#### HISTORIC AND DESIGN REVIEW COMMISSION

HDRC CASE NO: 2016-326

ADDRESS: 1801 N PALMETTO

APPLICANT: Robert Reyna
OWNER: Mary Figueroa
TYPE OF WORK: Install ramp

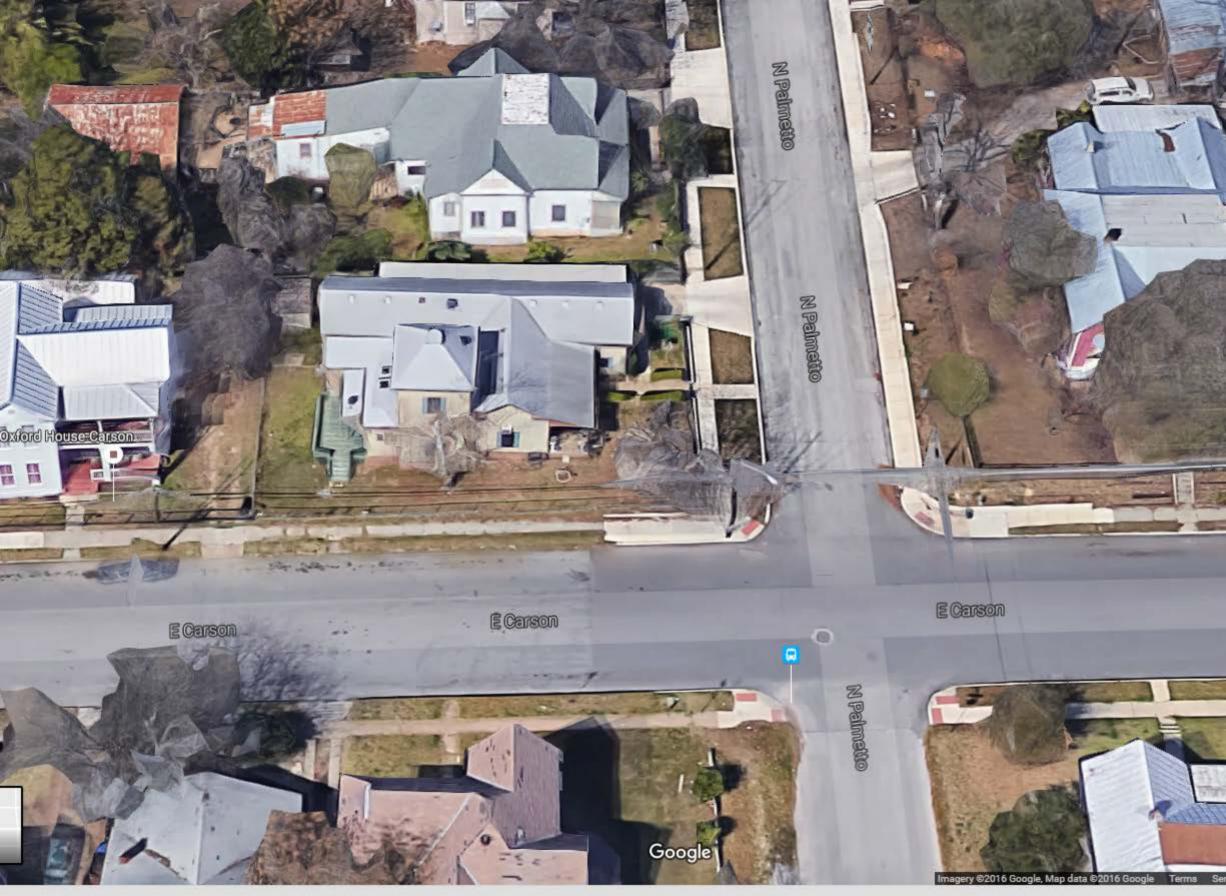
- c. The existing home is on a corner lot. It is a folk Victorian home with wood siding, a cross-gabled roof with composition shingles, a front porch and two wrought iron columns, and a front and side yard fenced in with a 4' chain link fence. The applicant is proposing to install a wooden ramp on the side of the historic structure along E Carson, accessing the rear porch entrance. According to the Guidelines for Site Elements 8.B., new ramps should be installed on the side or rear and should not damage historic materials or openings. Staff made a site visit on August 8, 2016, and found the ramp is set back from the primary façade and does not distract from the historic structure. Staff finds the proposal is consistent with the Guidelines.

Staff recommends approval as submitted based on findings a through c.
